- 8. Wahl Subdivision; KPB File 2022-092
Segesser Surveys / Wahl
Ninilchik Area**

ITEM 8 - WAHL SUBDIVISION

KPB File No.	2022-092
Plat Committee Meeting:	July 18, 2022
Applicant / Owner:	Beverly A Wahl of Sterling, AK
Surveyor:	John Segesser / Segesser Surveys
General Location:	Robinson Loop Road, Montgomery Avenue, Sterling

STAFF REPORT

Wahl Subdivision

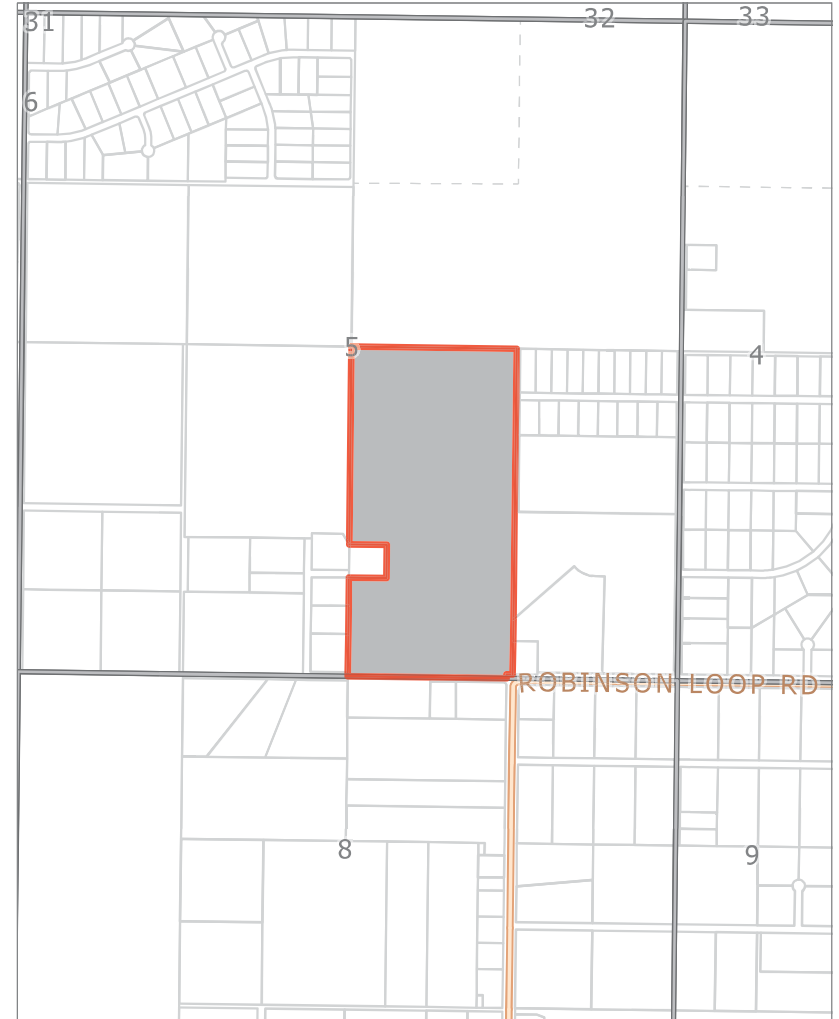
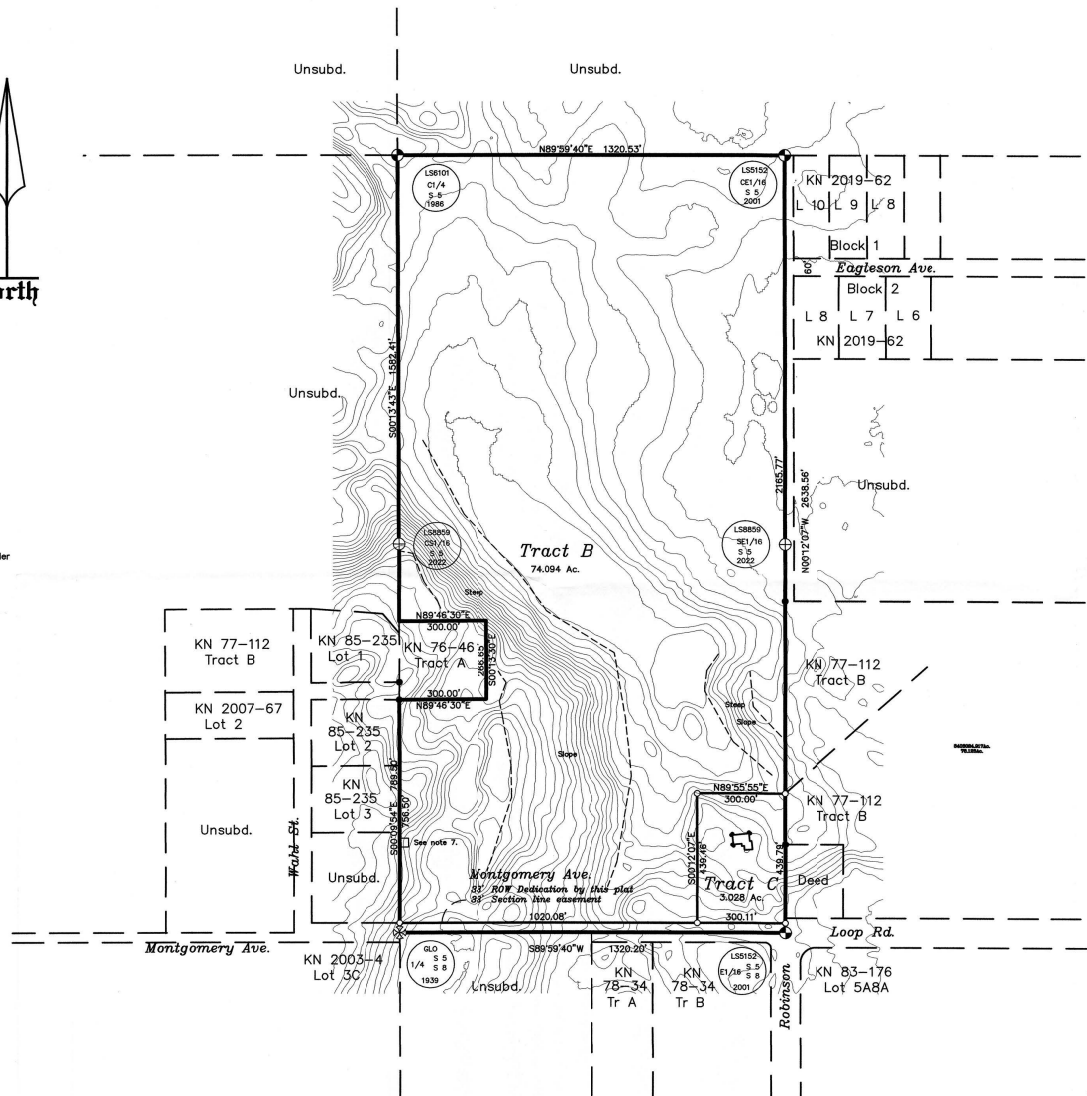
Site Investigation: Several areas of steep slopes are present throughout the proposed subdivision. Contours are present on the preliminary plat. **Staff recommends the top or toe of bluffs be shown or the areas of steep slopes remain on the final.**

A small portion of a depression area is located in the southwest corner where the right-of-way is proposed to be dedicated. No other wetlands appear to be present within the subdivision per KPB GIS data. Imagery does indicate there may be some low wet areas or standing water. **Staff recommends the wetland determination note be added and any low wet areas found during the field survey be depicted. If open water is present it should be shown and labeled as pond or seasonal pond depending on the situation.**

The plat is proposing to dedicate 10 foot wide utility easements adjacent to the dedicated rights-of-way that increase to 20 feet within 5 feet of the side lot lines. Due to the scale depicting the easements and the setback will be difficult. **Staff recommends** a detailed depiction of typical setbacks and easements be shown on the plat.

- C. The location, width, and name of existing or platted streets and public ways, railroad rights-of-way, and other important features such as section lines or political subdivisions or municipal corporation boundaries abutting the subdivision;
Staff recommendation: Provide width of dedications that are existing for Montgomery Avenue and depict and label the adjacent section line easements where dedications have not been granted.

- Any rights-of-way being shown should include a width label.
 - There is an overstrike on the Wahl Street label.
 - Provide a street name label for Adele Avenue in addition to a width label.

- The unsubdivided parcel to the northwest is Tract 2 of KN 84-328.
 - The unsubdivided parcel to the east is Lot 3A Block 1 of KN 2006-24
 - The northern Tract B to the east is Tract A-1 of KN 2006-70.

- The southern Tract B to the east is from KN 2004-82 and miscellaneous text appears within the lot boundary.
 - Lot 3C to the southwest is Lot 3-C.
 - On the vicinity map, place the site in the correct location.

- Correct the drawing of KN 85-235 Lot 1 as needed.

Correct plat note 3 code reference, should be 20.60.170.

Get complete copy of easement referenced in Book 273 Page 486 to correctly show location of easement.

Staff recommendation: There is a typo within the certificate of ownership and dedication. Comply with 20.60.190.
